#SP23-054

Project: Les Schwab Tire Center – Parker, CO
Date: 4.17.2026
Attention: Cynthia Liston Thye, City of Parker CO

Purpose of Change: Site Plan Adjustments

1 SITE PLAN
C100

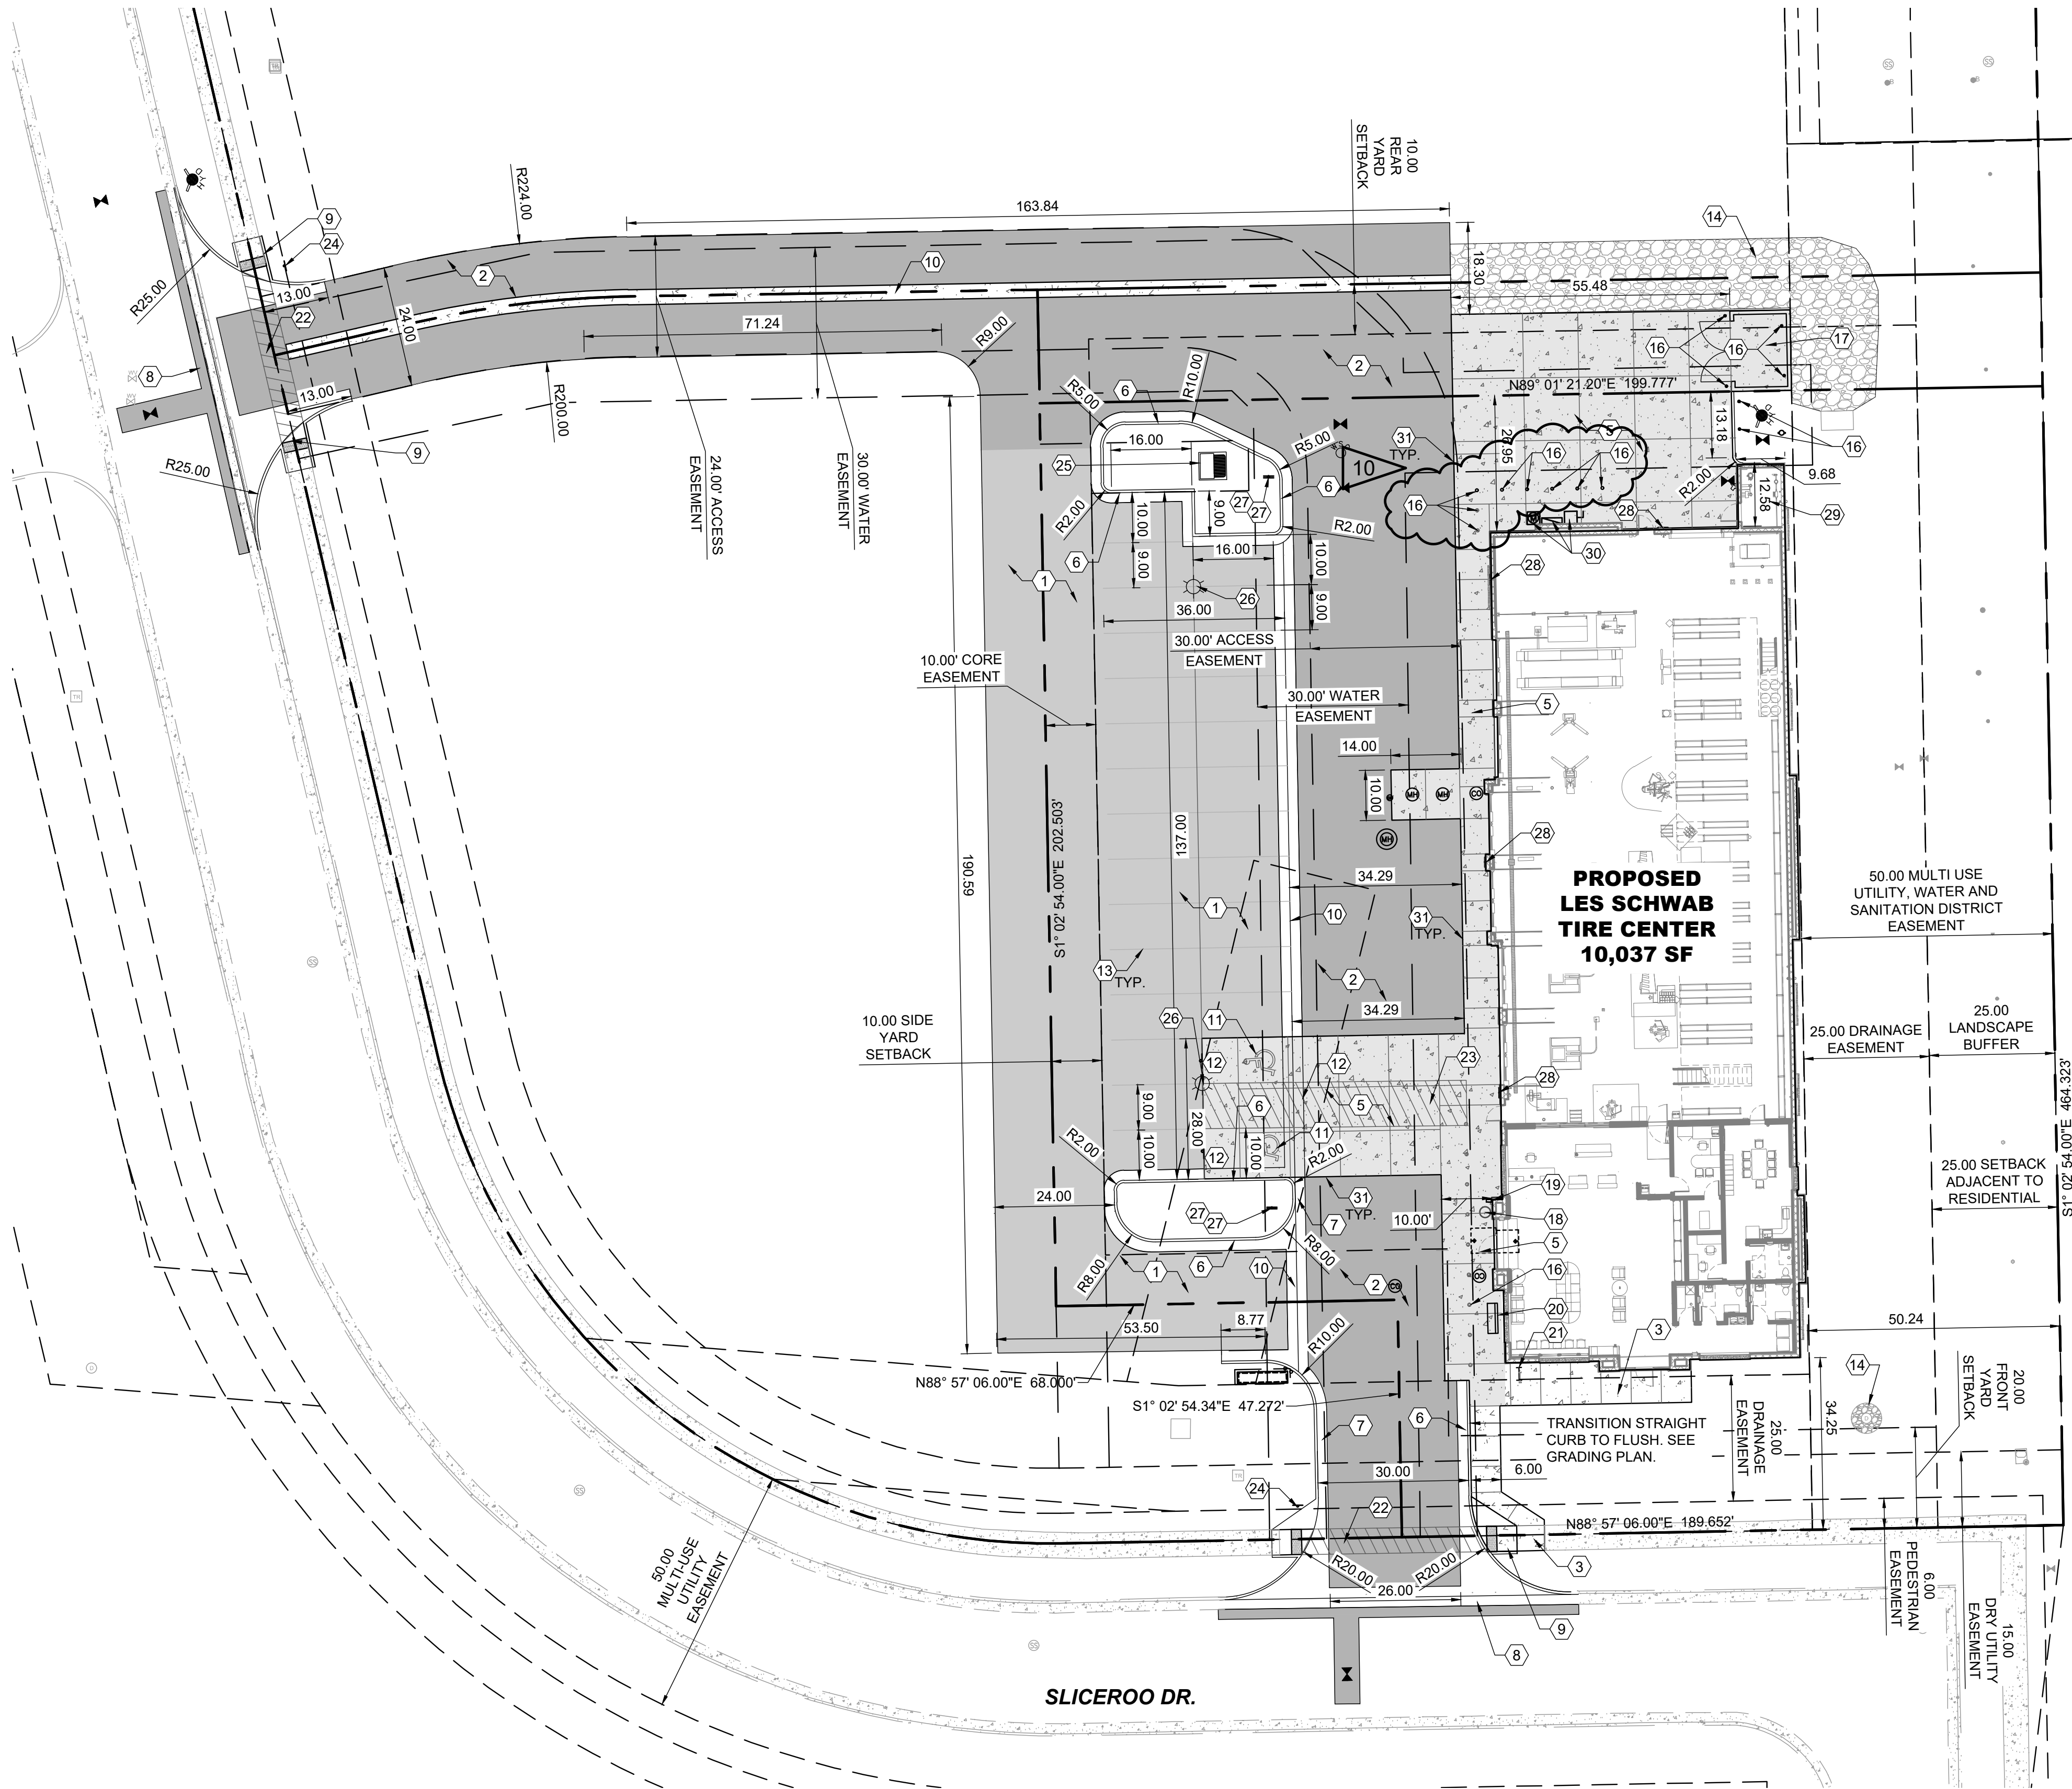
1. Attached is the current site plan, with updated bollards.
2. The Rain Bird is not on our property

1 ELECTRICAL SITE PLAN
SCALE: 1" = 20'-0"

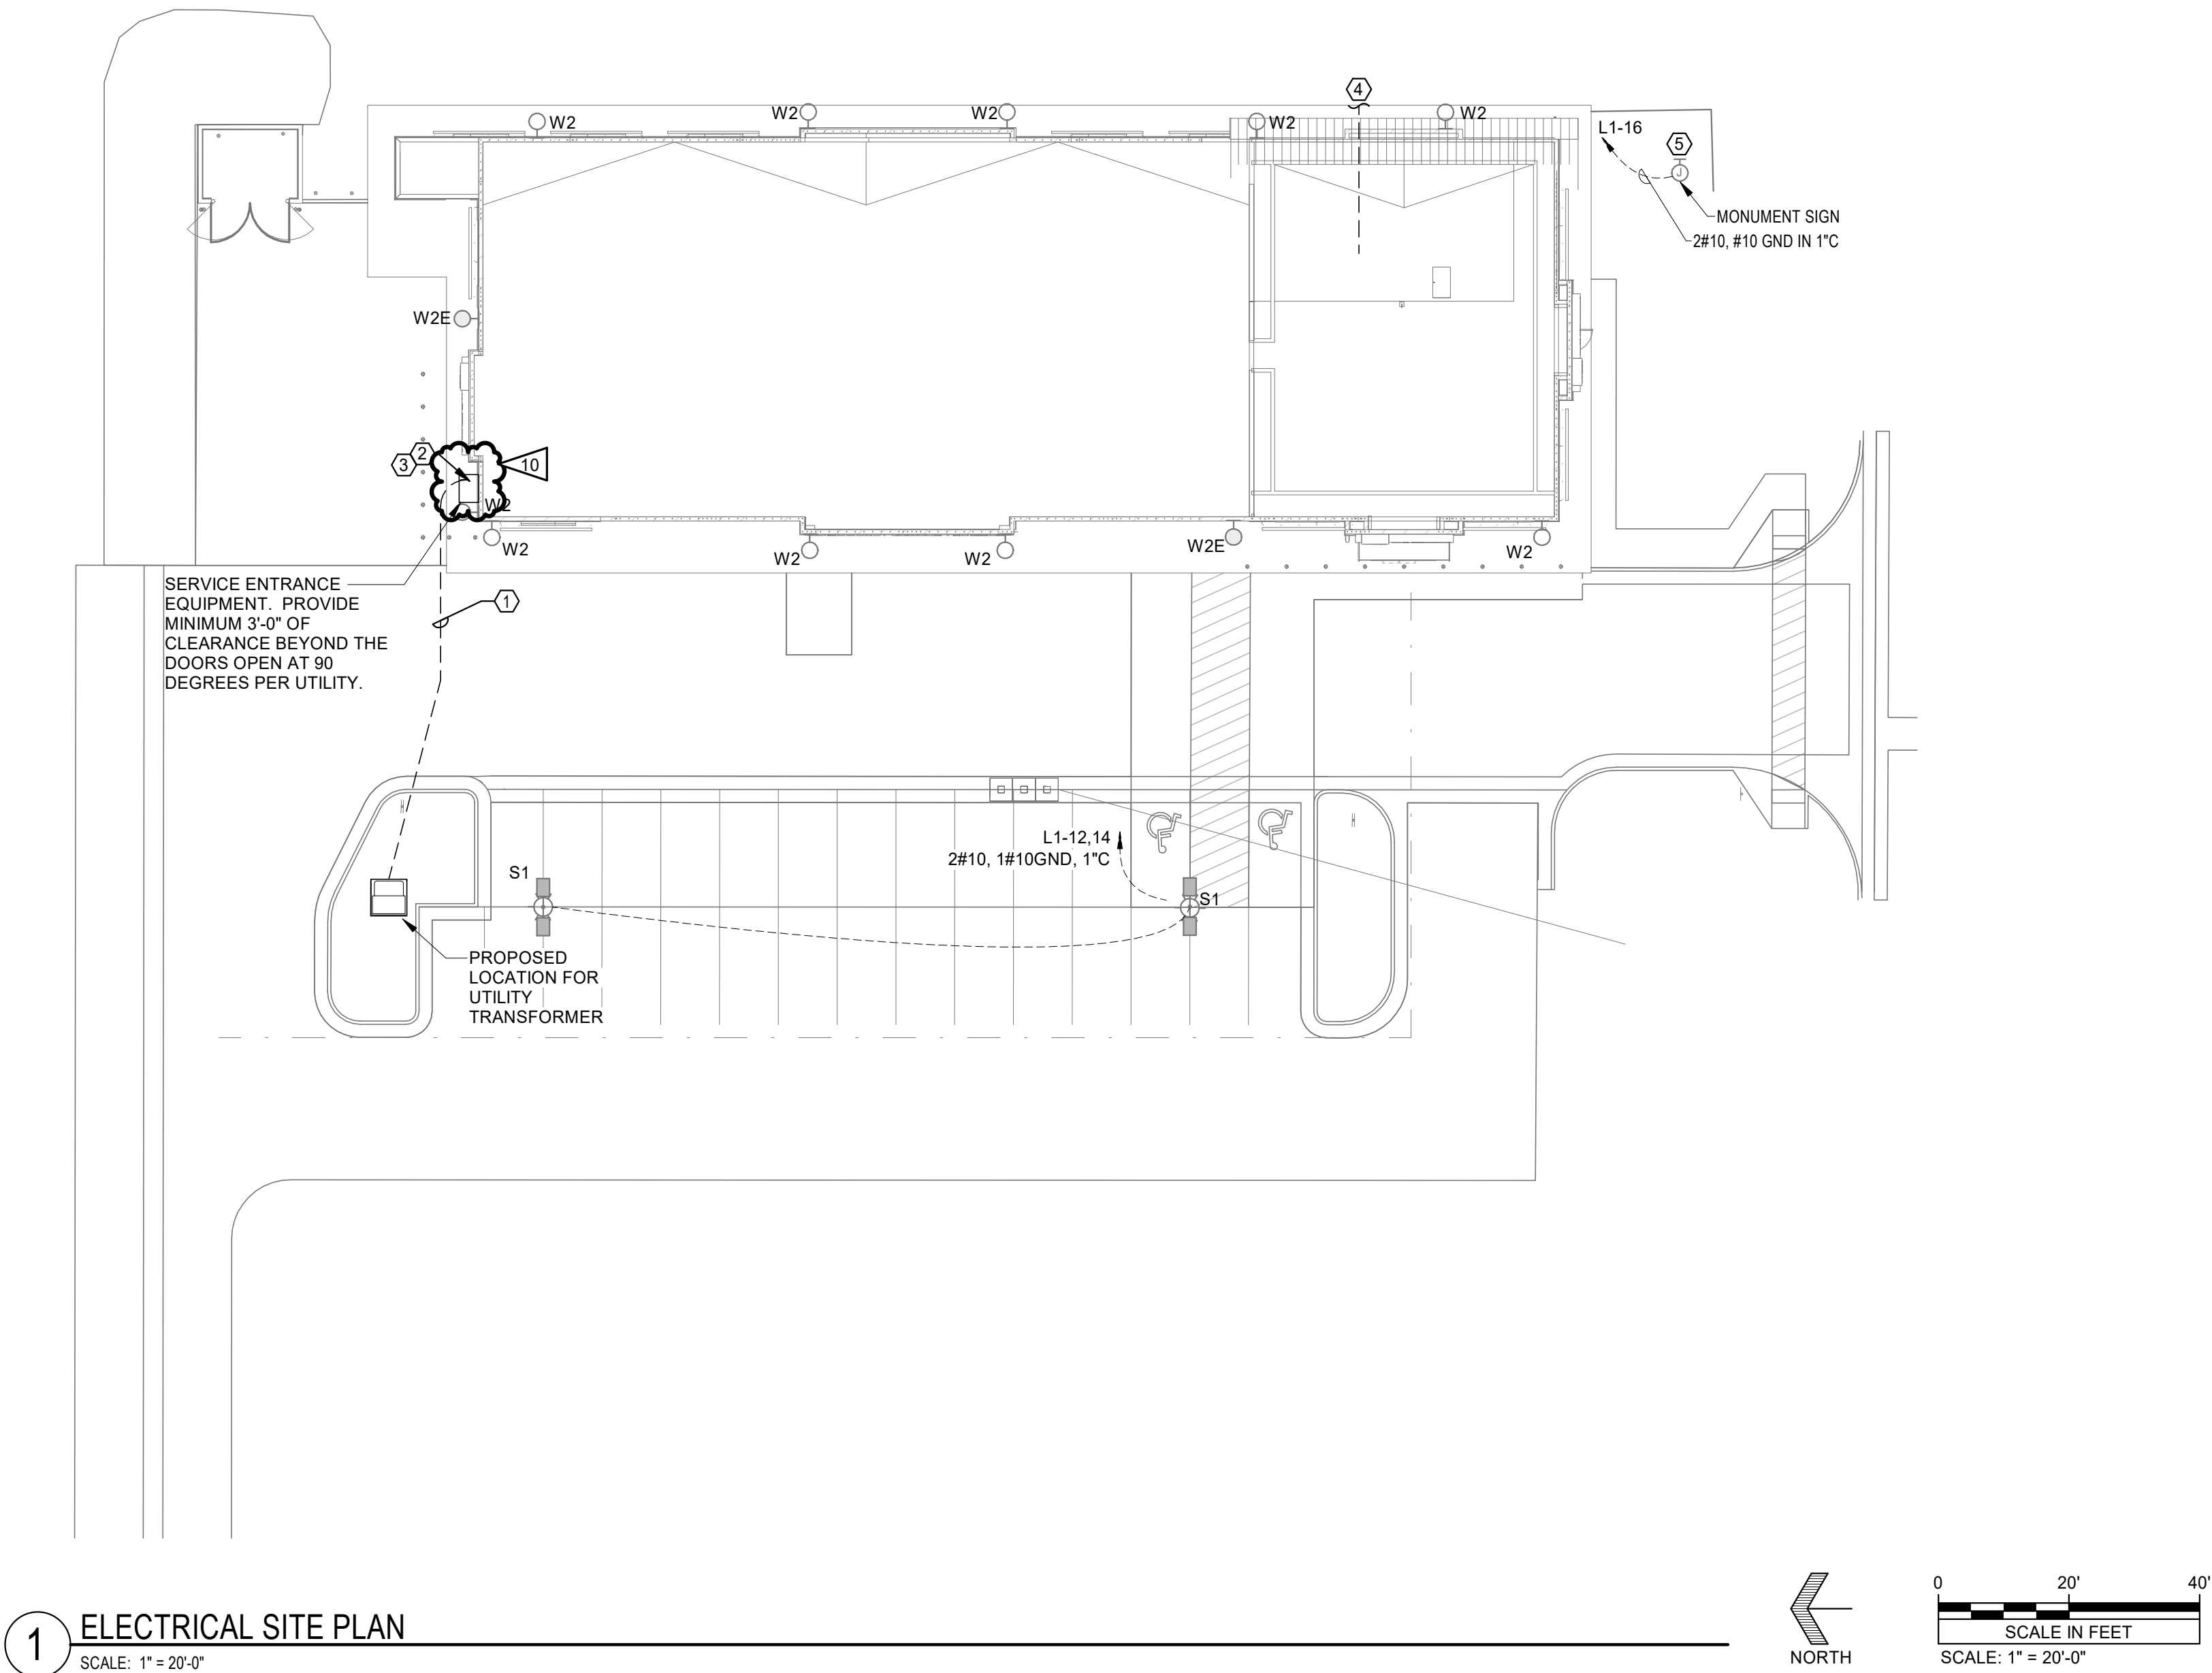
1. The initial site plan and cutsheet shows a double head. The cutsheet is for 1- 10 heads as shown below.

2. The wattage category on the entitlements photometric form has a 33/66 number in it for the S1 fixture. This means 33 watts per head for a total of 2 heads (66).
3. The South exterior is NOT considered a legal egress exit, therefore it does not require an exit light.
